INDESIT company

Model type:
AVTL104AG

Commercial code:
F033687

1140960 Exploded views

n1040345: Replacement of drum lock button TL EVOII.

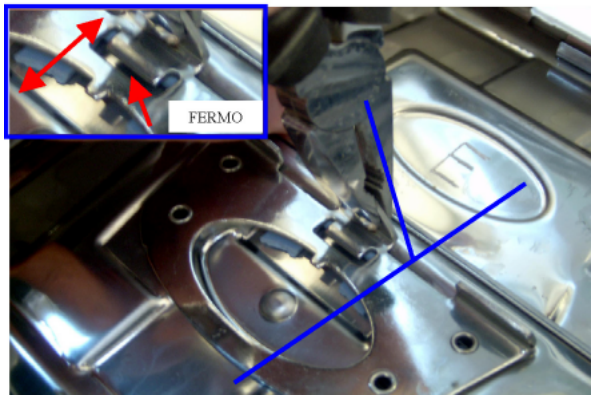
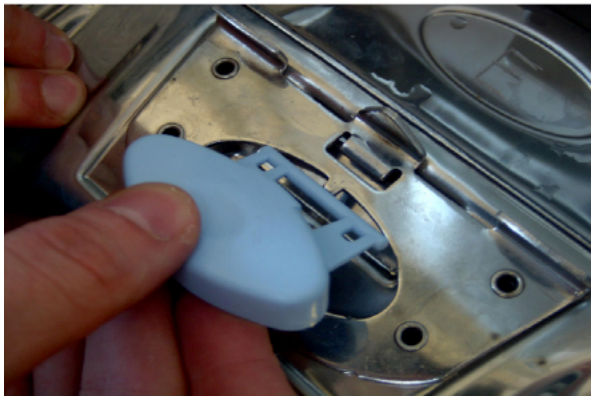
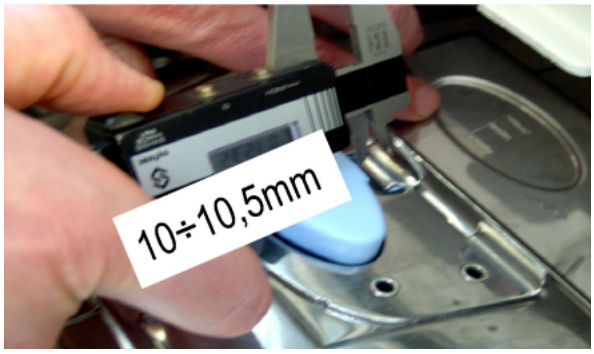
Tools and material needed: pliers, screwdriver, gauge, spring P/N Sat 114989, button P/N Sat 114990.

1) turn the central tip of the catch in the direction shown (FIG.1);

2) bring the tip to a vertical position and ensure that the broken button is disengaged from the catch restraint and can be removed (FIG.2);

3) remove the remaining part of the button with the aid of a screwdriver, taking care not to scratch the doors (FIG.3);

4) pre-assemble spring to button (FIG.4);

5) insert button between catch and door (FIG.5);

6) bring the button into position and arrange the spring in its location in the door (FIG.6);

7) turn the central tip of the catch in the direction shown to return it to its starting position (FIG.7);

8) check the distance between button and catch (FIG.8);

9) check correct operation of the button when opening and closing the doors (slight inclination errors of the catch can result in faulty closing of the doors) (FIG.9).

n1040382: Drain pump with bayonet-style filter - top Loading Brembate

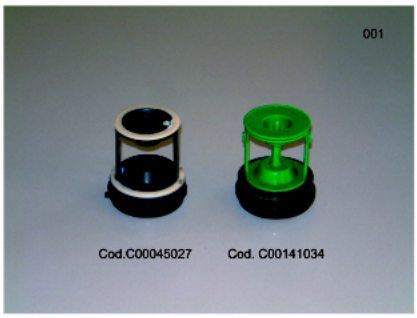
From serial no. 51021.0001 a new drain pump with bayonet-style filter has been installed on all top loading washing machines manufactured in Brembate.

New parts:
C00141862 - Drain pump
C00141034 - Pump filter kit

Premodification parts:
C00111409 - Drain pump
C00045027 - Pump filter kit

The new parts can be used instead of premodification ones.

N1040404FIG1

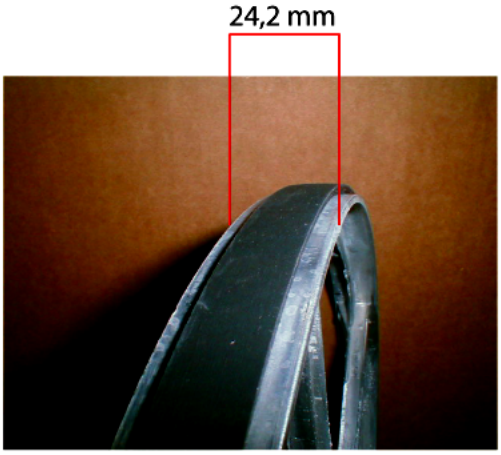
n1040404: New pulley installed on top loading washing machines up to 1000RPM (NO tub lock)

From serial no. 51202.0001 the pulley track has been widened from 21.2mm to 24.2mm (see picture N1040404FIG1).

new pulley
C00142832 - D280 24.2 mm track

Premodification pulley
C00083912 - D280 21.2 mm track

The new pulley can also be used on premodification versions of the models referred to in this release.
